24 October 2023

PPSSWC-236 & PPSSWC-237: 184 LORD SHEFFIELD CIRCUIT, PENRITH: **RESPONSE TO COUNCIL ASSESSMENT REPORT**

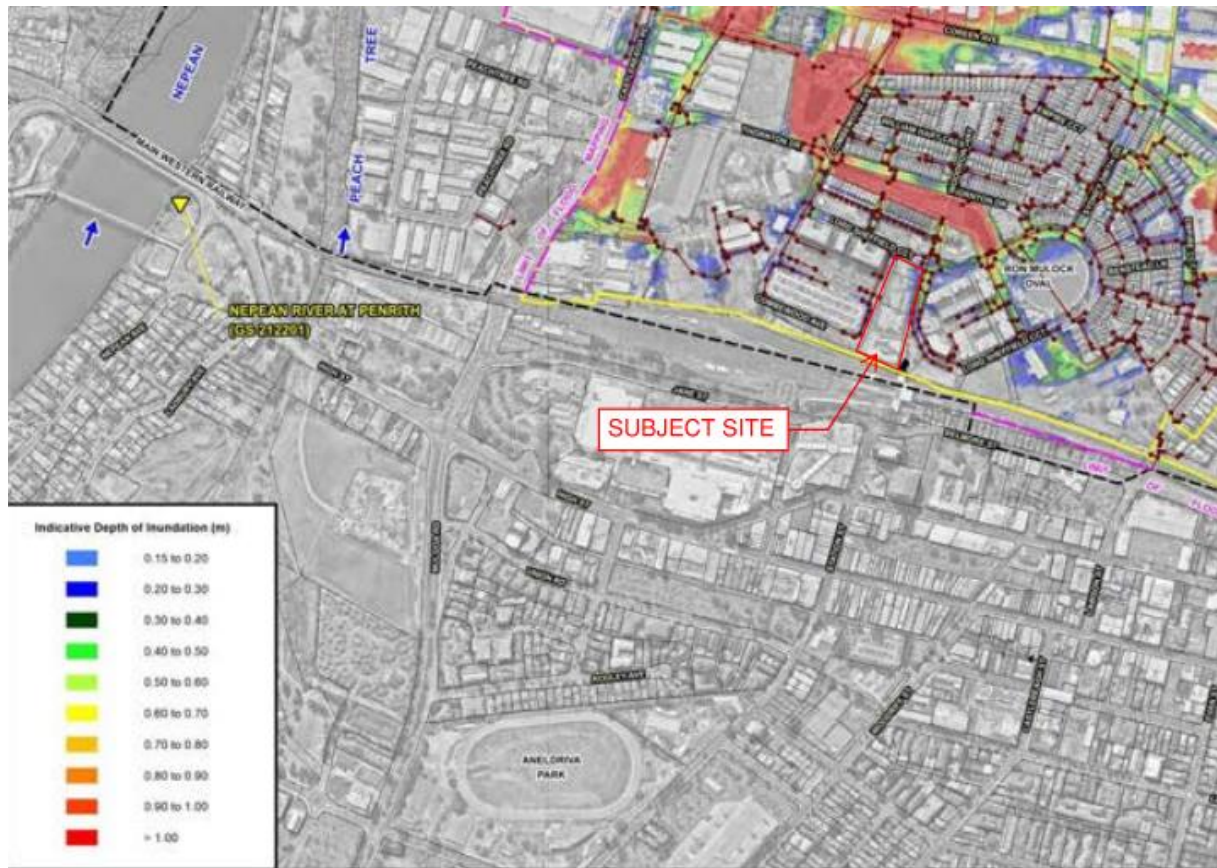
Page 34 of Council’s Assessment Report notes comments from Council’s Development Engineer relating to concerns in relation to flood planning, and specifically that the proposed bund wall does not protect potential flows coming down the adjoining lot of paved seating area, which slopes towards the subject site. Further, Council note that floor levels are to be at least 0.5m above the 1% AEP or the building flood-proofed to this level.

The applicant’s flood engineer (Northrop) have reviewed this and note the following:

- The Cranebrook Floody - <https://yoursaypenrith.com.au/cranebrookfs> has been reviewed. This is currently on exhibition and not ‘formally’ accepted yet by Council, however it does now include the subject site in the model extents.
- Upon reviewing the maps presented in what is proposed to be the final version, the site is shown to be not flood impacted in either the 1% AEP local catchment flooding. Only minor flood depths are observed even in the PMF event on the northeastern extent.

- The comments regarding the eastern boundary of the site being below the 1% AEP are inconsistent with the information presented above.
- It is noted that there was previous discussions regarding the 1% AEP flood extent shown within the rail corridor to the south, however it was previously discussed with Council that these flows were not represented accurately, as the 1D-Network /culverts did not appear to be represented in the 2D model geometry presented within the CBD flood study.

- Regardless, to alleviate Council's concerns it was proposed that a low height flood wall or earth bund would otherwise protect the development from the potential of surface flows, if they should overtop the drainage channel and flow towards the north.

- It is anticipated that any surface flows would be contained within the road reserves and present a low risk of flooding in this case.
- In Northrop's opinion, the Flood Planning Level of 27.40m as suggested by Council is not valid for the full site, as the subject site sits beyond the flood model extents from the CBD flood study, and the more recent Flood Study that includes the site (as discussed above) does not indicate the site is impacted by the 1% AEP, or show any inundation up to and including the 0.2% AEP – 1in500 year event). Even in the PMF event, minor flooding is shown only in the North Eastern Corner.
